United States Department of the Interior

In Reply Refer To:
FWS/ES
ER-75/972

Reference is made to Mr. Knighton's letter dated September 24, 1975, requesting our review of the environmental report to accompany the application for a facility license amendment for extension of the operation with once-through cooling for Indian Point Nuclear Generating Station, Unit 2 (50-247); and ER Supplements 1 and 2, Westchester County, New York. These comments do not constitute our final assessment of the need for closed-cycle cooling at Unit 2, because we have not completed our analyses of Supplements 1 and 2 to the subject environmental report. Comments on these will be transmitted in the near future.

FIGURE / .--Landings by haul seines and numbers of haul seines in New York, 1929-1972

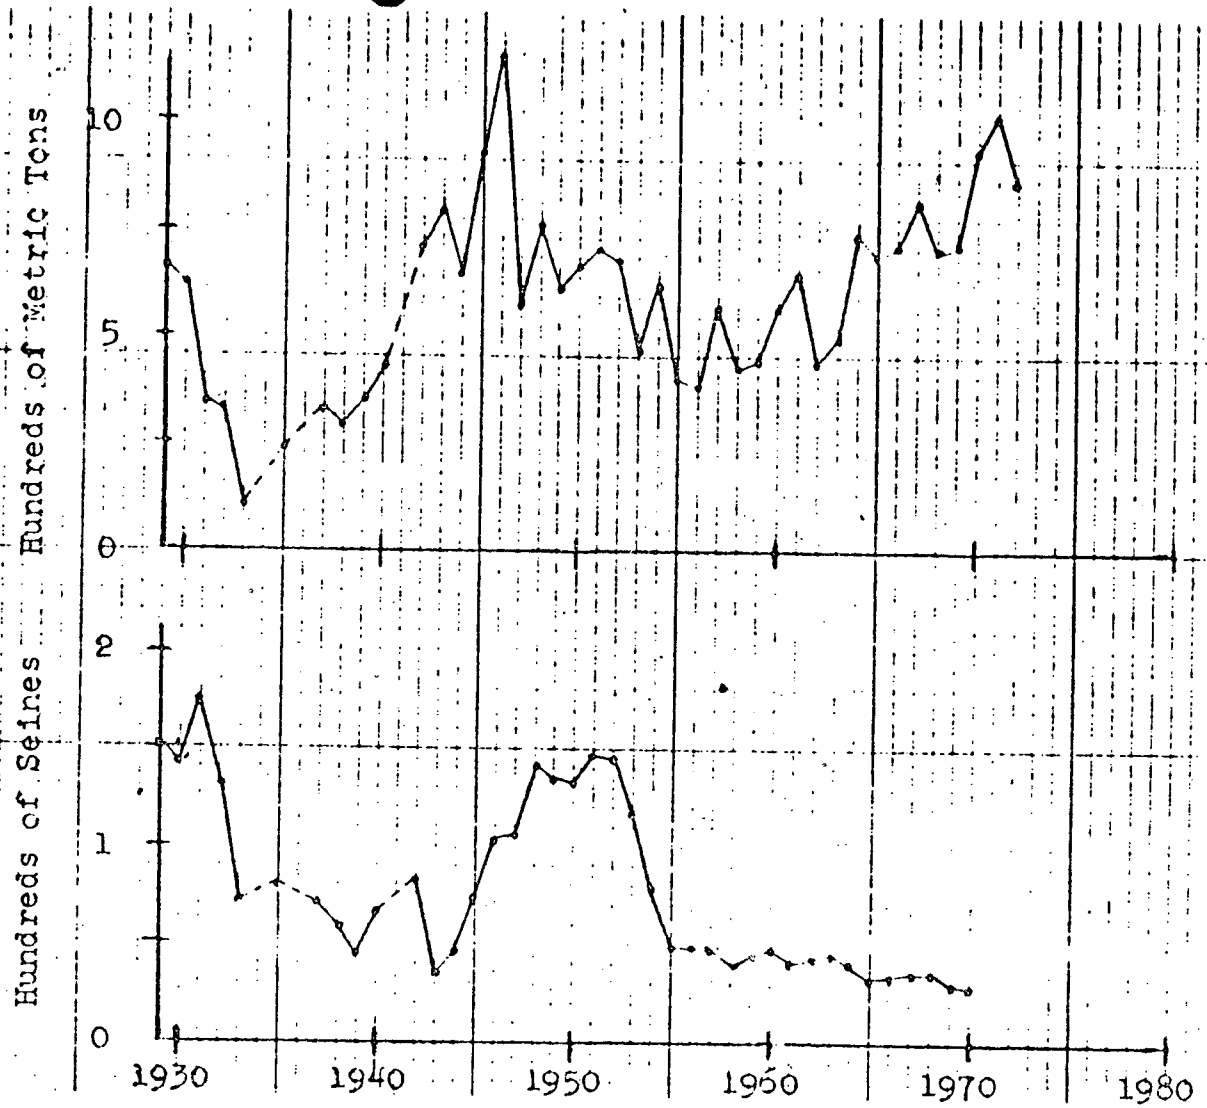
Use of various indices of fishing effort to develop CPUE estimates requires extreme caution and detailed understanding of the local fishing industry. The number of units of licensed gear is not always an accurate index of the number of units of operating gears. Koo's (1970) work in Chesapeake Bay may not be directly applicable to New York and New Jersey waters, where major differences in effective fishing effort and strategy exist among haul seines, pound nets, and various types of gill nets (See attached Tables 1-5 and Figures 1-5).
